July 20, 2022

Mr. Erik Gates  
City of Aurora, Planning Department  
15151 E. Alameda Parkway, Suite 5200  
Aurora, CO 80012

RE: Comment Responses for Kings Point South PA 1-4 (#1567816)/Pre-Application Meeting held August 19, 2021

Figure 4.2-3: Motor Courts

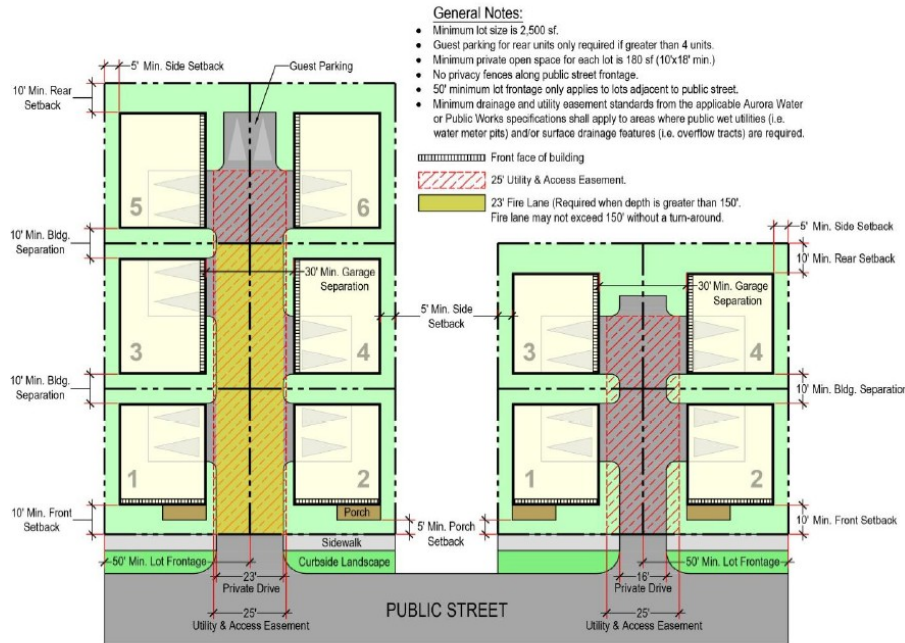
The minimum lot size for motor courts is 2,500 square feet, and the minimum width of each lot is 50 feet. Motor courts dwellings abutting a street shall have the front door facing the street. The front setback for homes abutting a street shall be 10 feet from the house and 5 feet for a porch. As the motor courts that are proposed all include 6 dwelling units, at least two guest spaces must be provided. When the sides of rear of motor court groups face streets the use of privacy fences should be minimized to reduce "fence canyon" appearances. *Noted.*
